Planning comments - V1  
Matthew Fitzsimmons - 8/31/22

# Romens Subdivision

Final Plat

## FINAL PLAT LETTER OF INTENT ROMENS SUBDIVISION

Figure 1 Map showing the location of the proposed subdivision in El Paso County, Colorado.

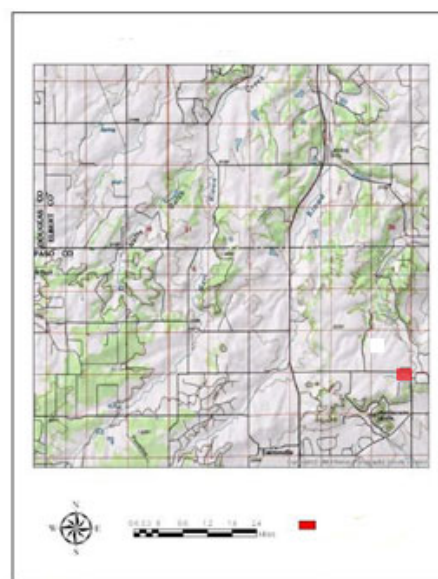
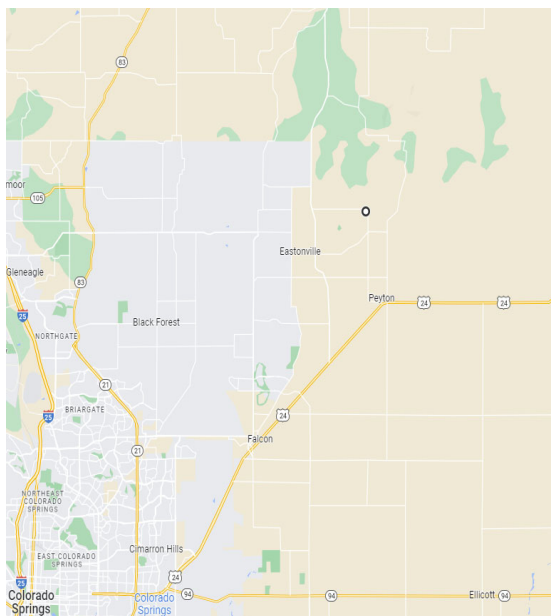
The EPC assessor has this property listed at 40 acres. please explain.
